# United States Department of the Interior

The National Park Service (NPS) has reviewed the Draft Supplemental Environmental Impact Statement (SEIS) to the Generic Environmental Impact Statement for License Renewal of Nuclear Plants Regarding Subsequent License Renewal for Turkey Point Nuclear Generating Unit Nos. 3 and 4 (EPID No.L-2018-LNE-0001) Docket ID NRC-2018-010.

National Park Service Detailed Comments on the Draft Supplemental Environmental Impact Statement (SEIS) to the Generic Environmental Impact Statement for License Renewal of Nuclear Plants Regarding Subsequent License Renewal for Turkey Point Nuclear Generating Unit Nos. 3 and 4 (EPID No.L-2018-LNE-0001) Docket ID NRC-2018-010.

**Figure 1.** Groundwater tritium concentrations in the Turkey Point Cooling Canal System, adjacent areas, and within the Card Sound region of Biscayne Bay.

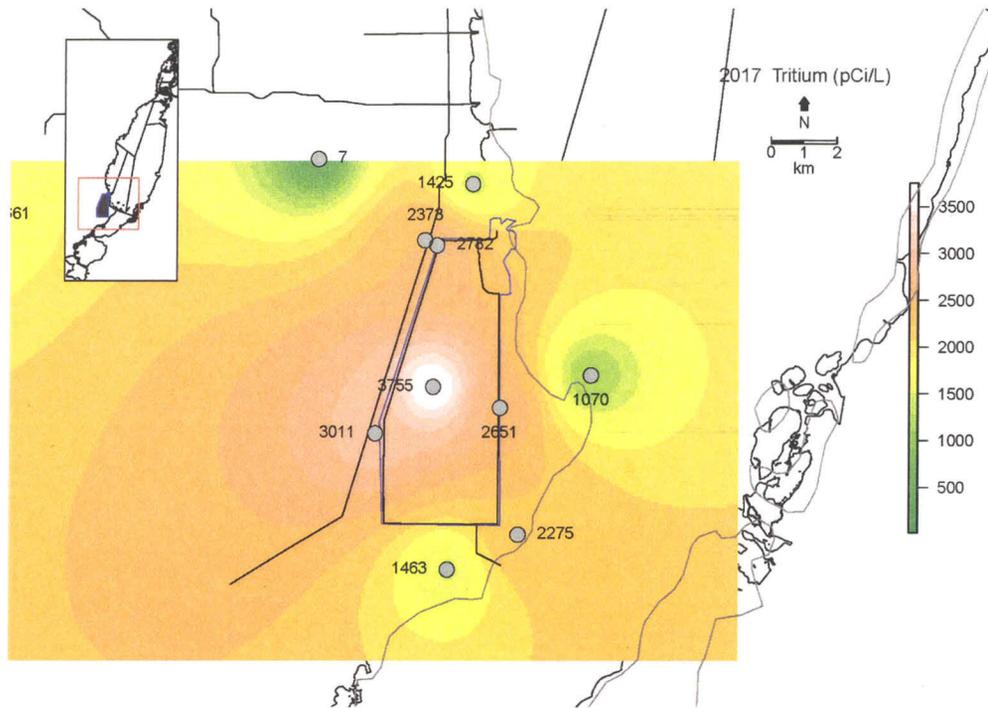
FPL, through guidance by the Florida Department of Environmental Protection (FDEP), uses the presence of tritium to trace water movement from the CCS into surrounding areas. As tritium in natural conditions is expected to be lower than 20 pCi L<sup>-1</sup>, concentrations in sampled waters indicate higher levels that are attributable to the CCS. Groundwater sampled in a series of wells within the CCS and Card Sound show that concentrations are exceptionally higher than the background level (Figure 1). These extremely elevated levels of tritium are a clear indicator of CCS water infiltration into the bay and ultimately a signal of the adverse impacts the bay is experiencing as a result of operations of the CCS. This is further evident in the elevated groundwater samples concentrations for Total Nitrogen (TN) in Figure 2 and Total Phosphorus (TP) in Figure 3.

The Draft SEIS states that new technology established in May 2018 will limit CCS waters to the boundary of the CCS and prevent intrusion into the bay in five to 10 years and as such Groundwater impacts were identified as “small to moderate.” Assumptions about the effectiveness of these remediation efforts to make predictions about future conditions introduce uncertainty. Instead, this technology should be tested and the assertion that the hypersaline plume will recede back to the boundary of the CCS should be assessed in the identified five-years. With the high levels of tritium already persisting in Card Sound groundwaters, the NPS recommends changing the impact rating for surface water to “Moderate-Large.”

**Figure 4.** Total nitrogen in Turkey Point Cool Canal System and adjacent surface water in Card Sound region of Biscayne Bay.

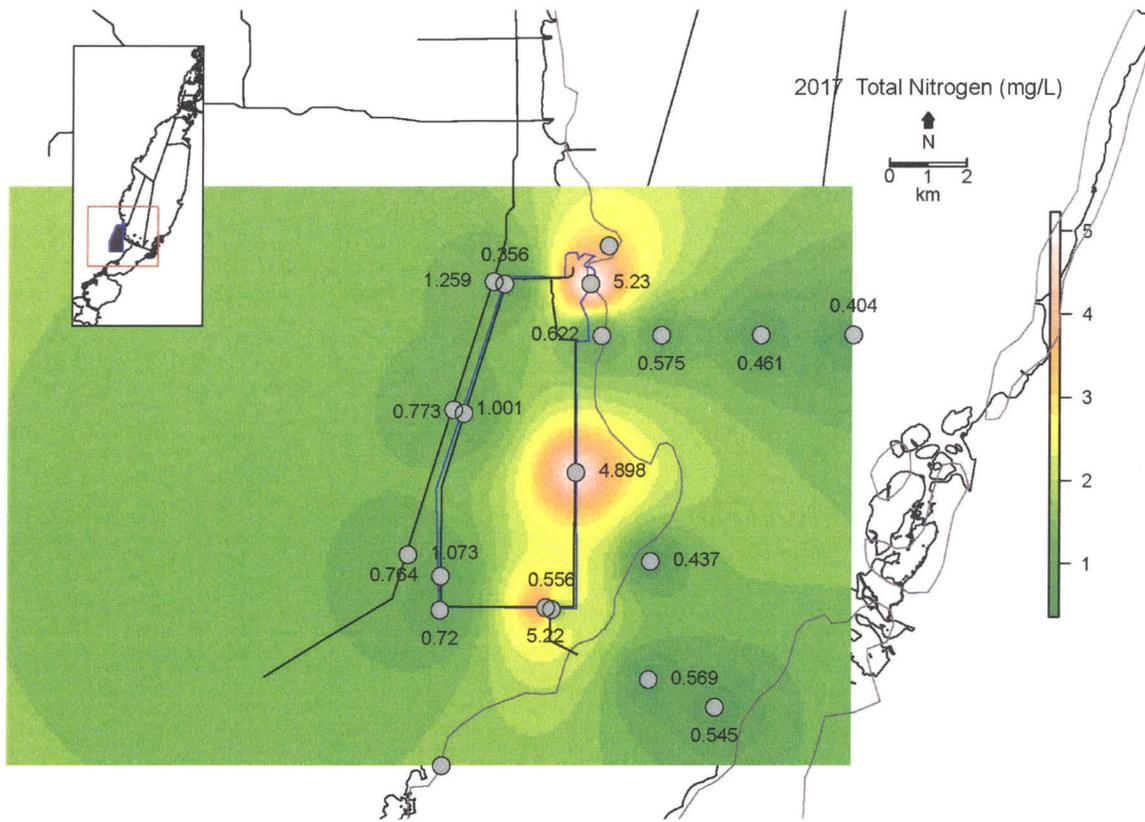
3) Water Quality Impacts Biscayne Bay – The numeric nutrient criteria, established by the Florida Department of Environmental Protection, does not appear to be taken into account when scoring the impacts to surface water resources in Biscayne Bay in the EIS. Review of these nutrient criteria over the past few years shows that Total Nitrogen (TN) and Chlorophyll-a (Chl-a) have exceeded these criteria. Calendar year 2017 is a prime example of these conditions. Monitoring for the Turkey Point Cooling Canal System (CCS), shows that TN concentrations in the surrounding canals were greater than the TN numeric criterion ( $0.33 \text{ mg L}^{-1}$ ) by as much as three times (Figures 4 and 5). Similarly, sample locations established as transects from the east side of the CCS within Card Sound, all show TN concentrations that exceed the criterion with the highest values found in the locations closest to the CCS (Figure 4). Transects established from the east boundary of the CCS into Card Sound also show that Chl-a concentrations exceed the criterion (Figures 6 and 7). Given these elevated bay conditions appear to be linked via groundwater transport (see comments in the groundwater section) to the CCS, the rating established in Table 2-2 appears to underestimate the existing impacts of the CCS on Card Sound and the score, based on existing data, should be elevated to “Large.”
